CCK-2568-22

ADDENDUM # 4

CONSTRUCT/ IMPROVE GREEK HOUSING (DELTA GAMMA) Bid Package #2 – All Work Categories

UNIVERSITY OF KENTUCKY
 2555.0 Construct/Improve Greek Housing
 (Delta Gamma House)

DWG. NO.: A740

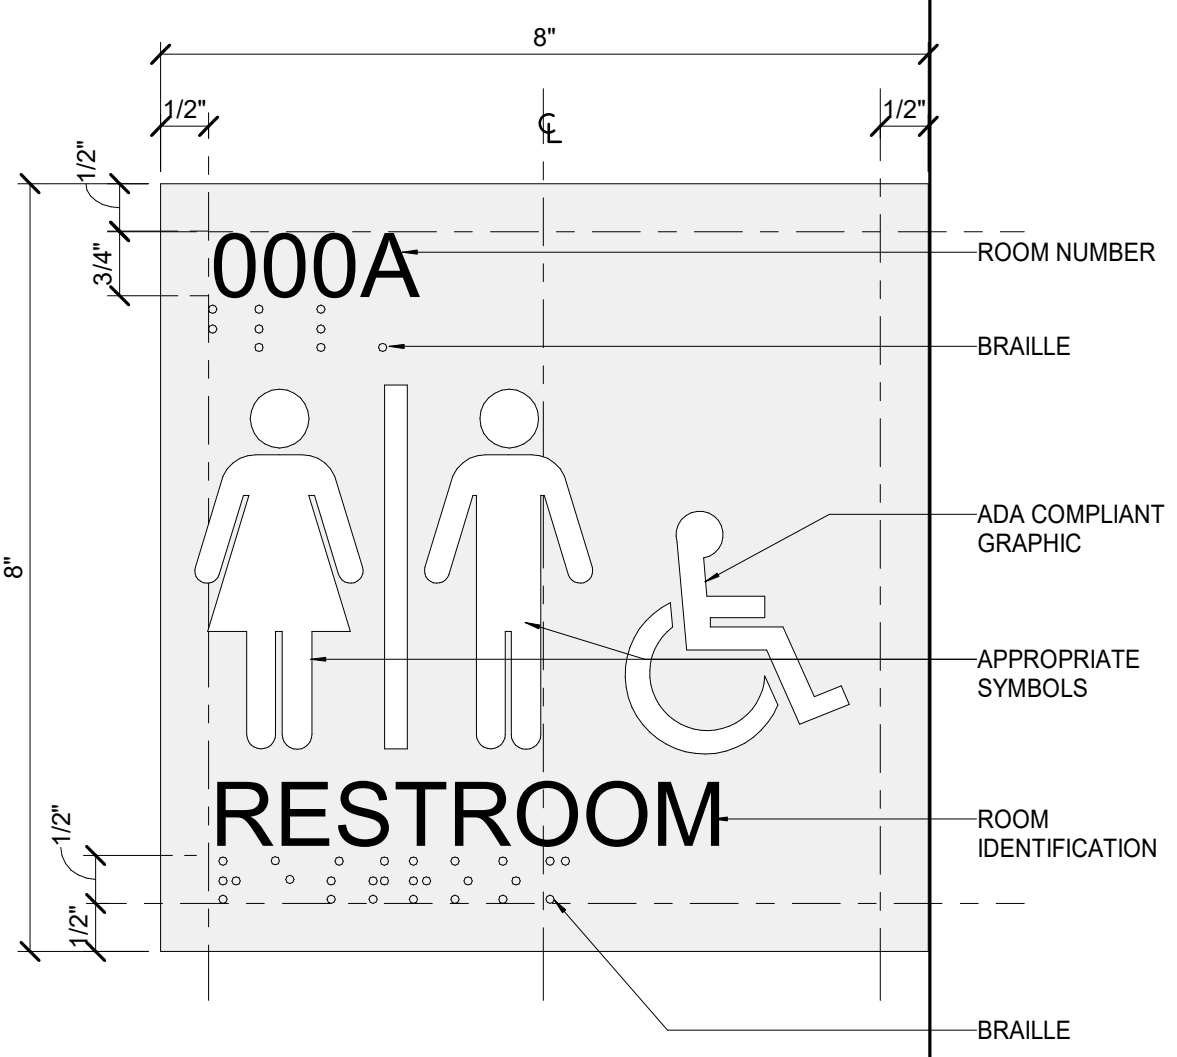
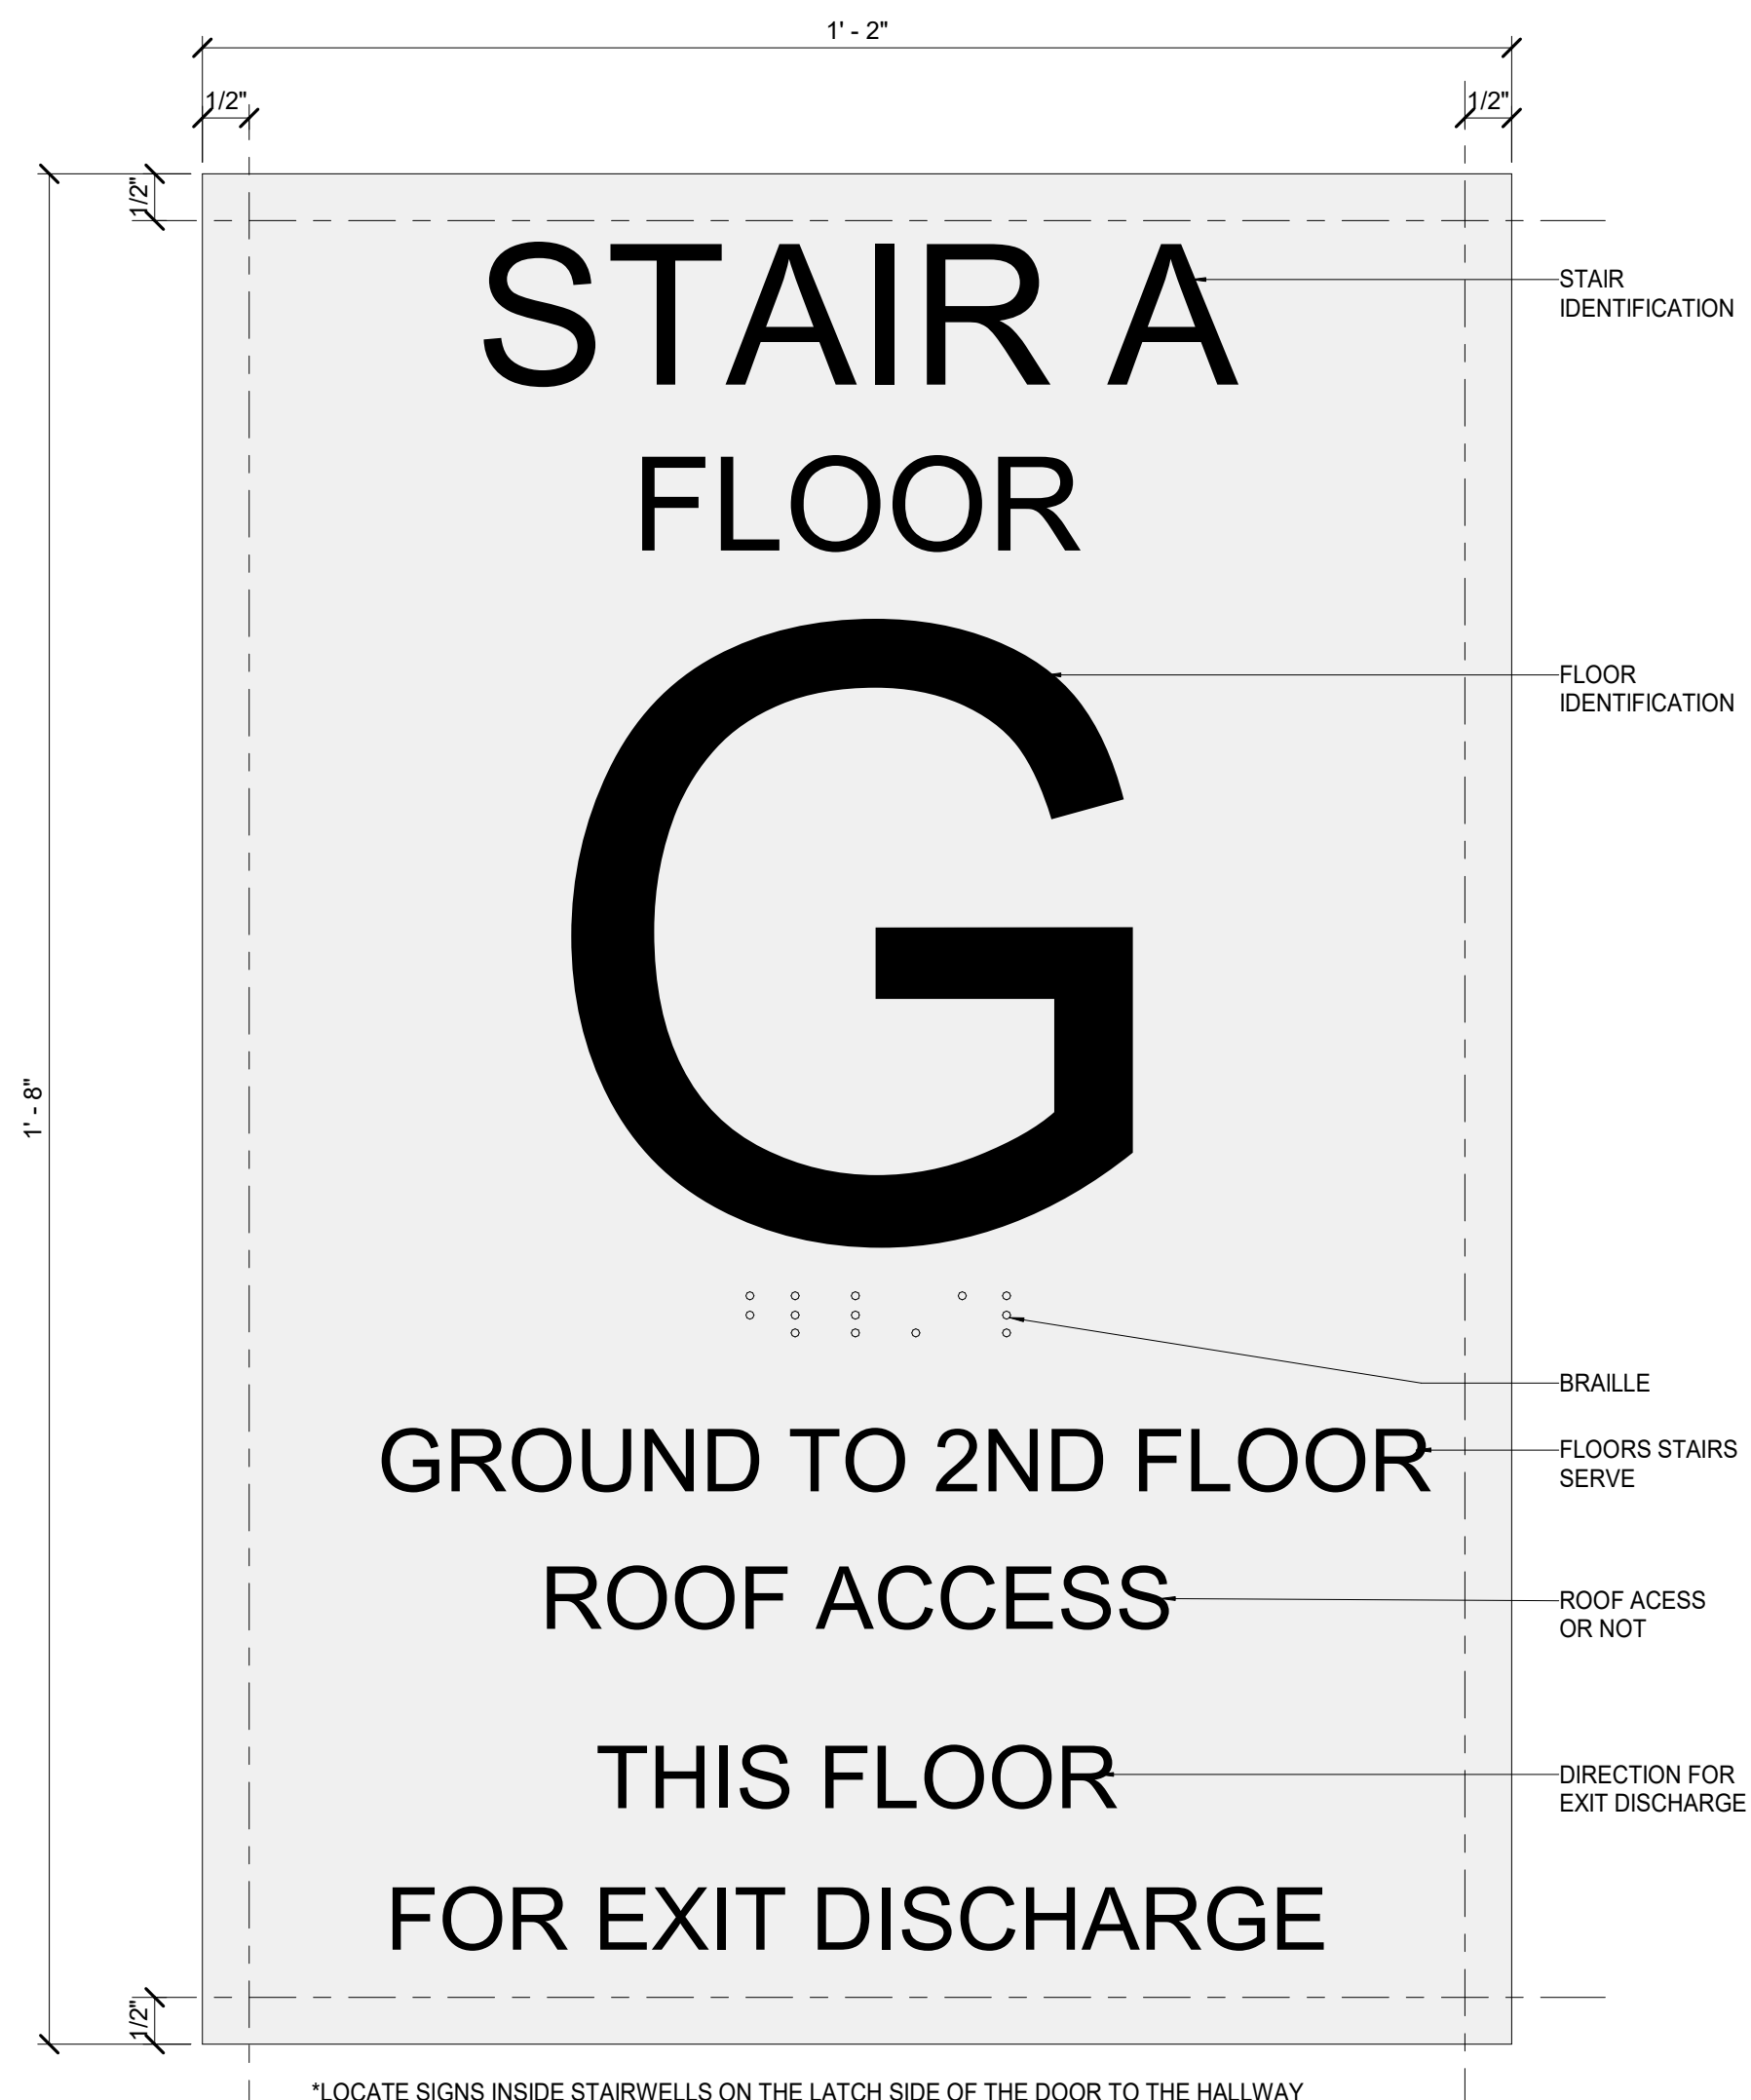
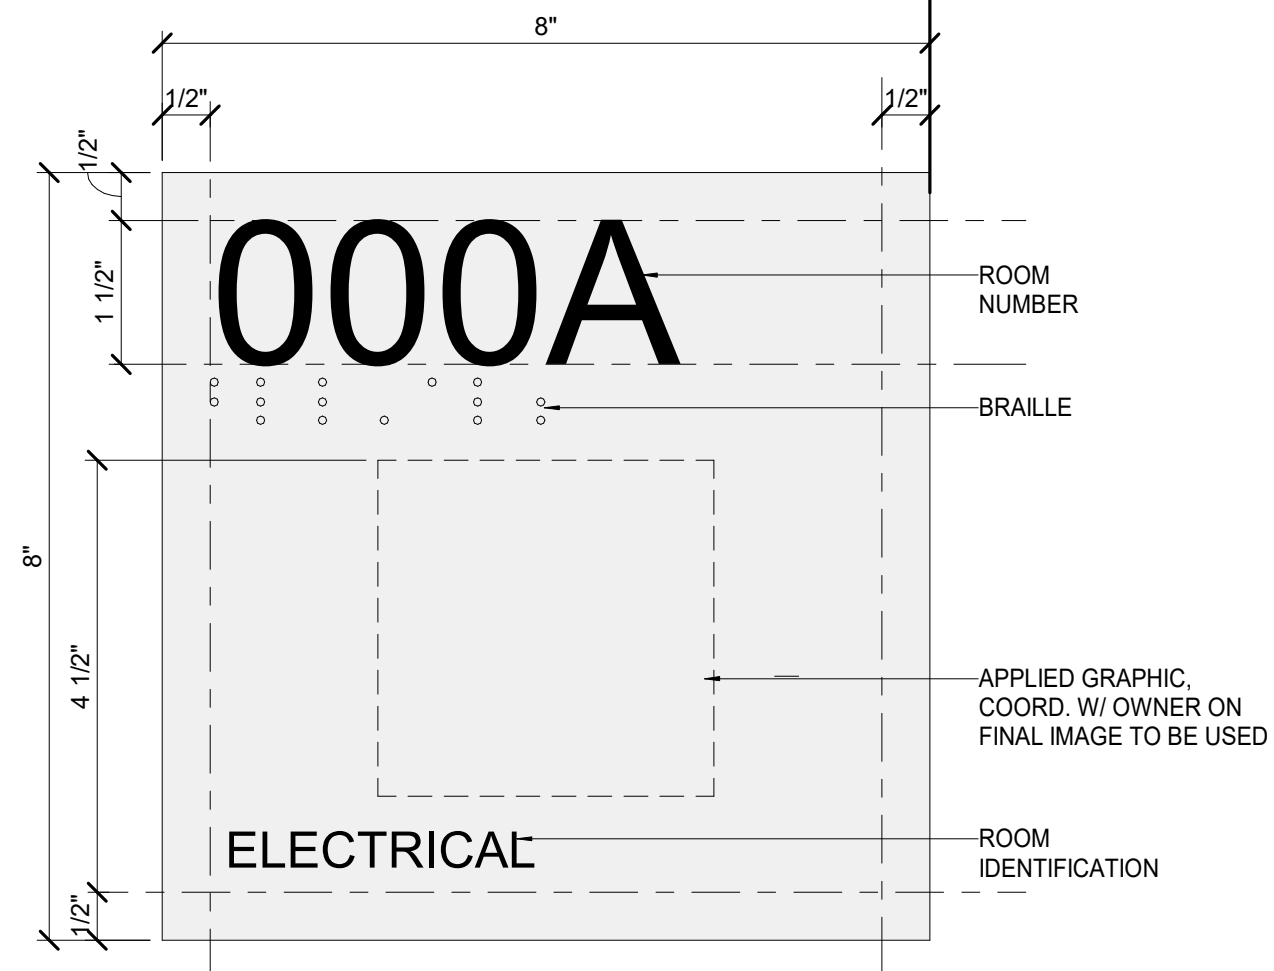
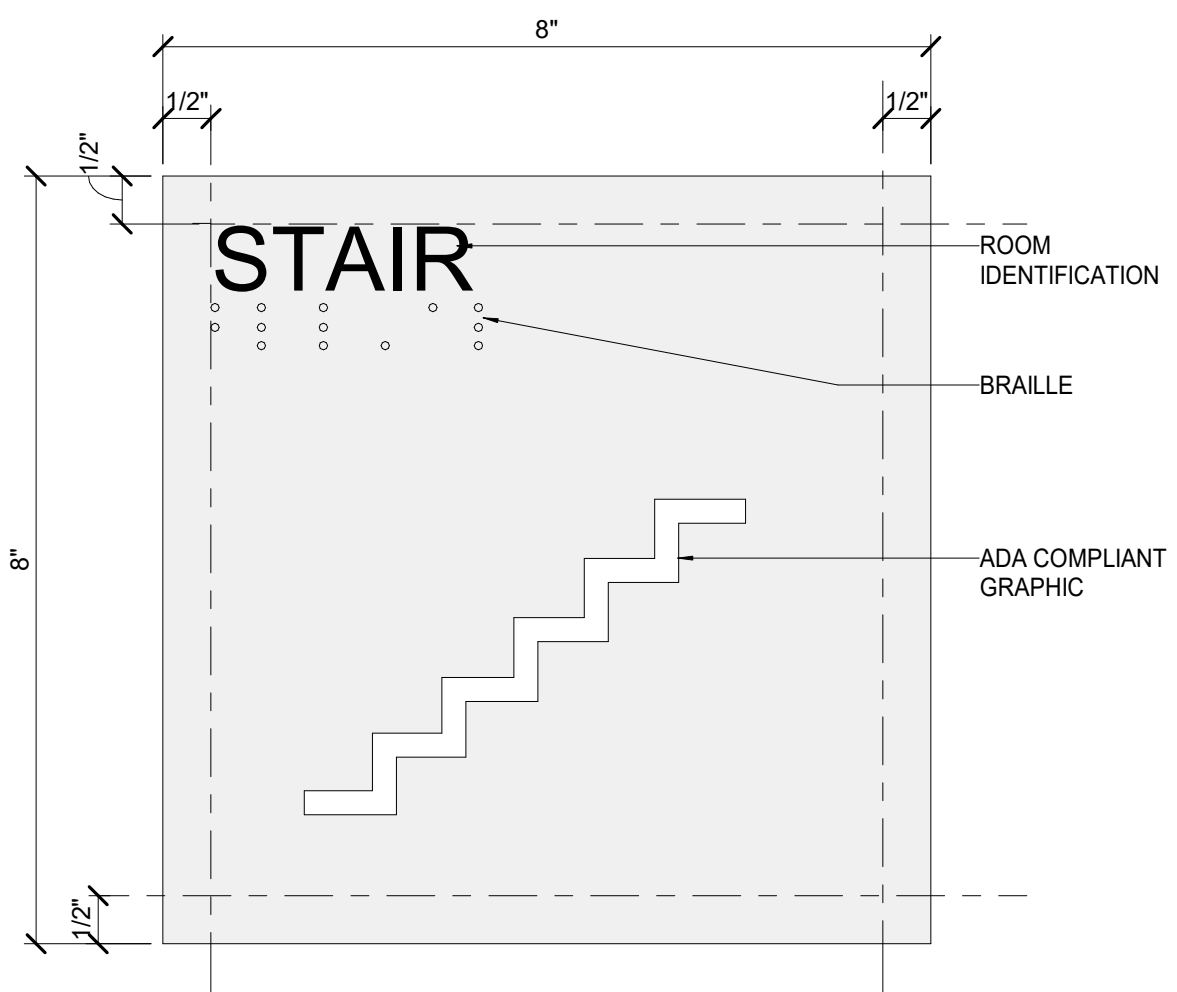
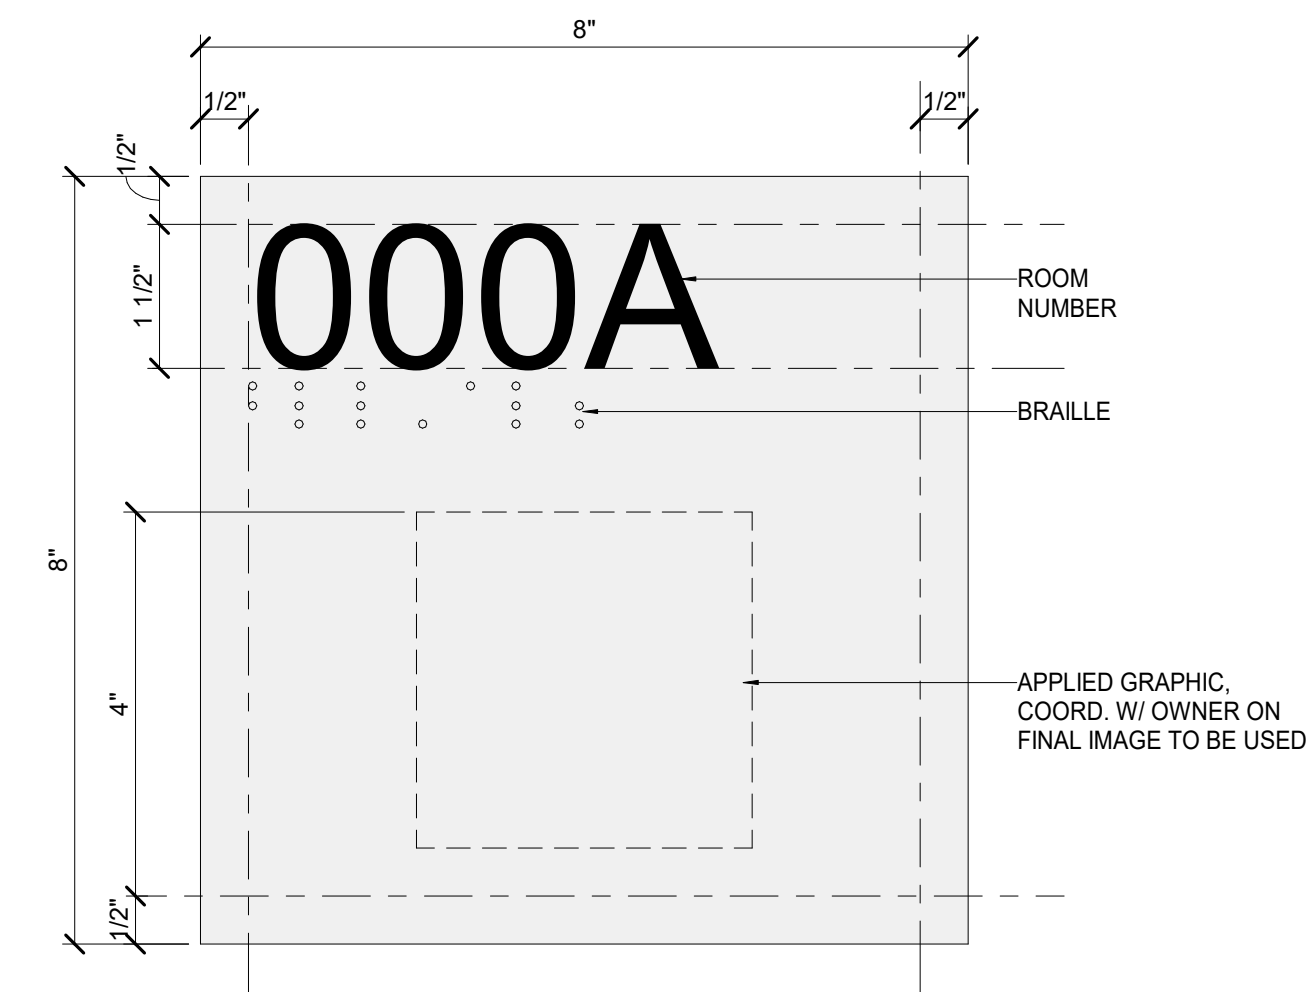
- Removed Exterior Building Signage from sheet
- Added and revised signage types/ elevations
- Updated Signage Schedule
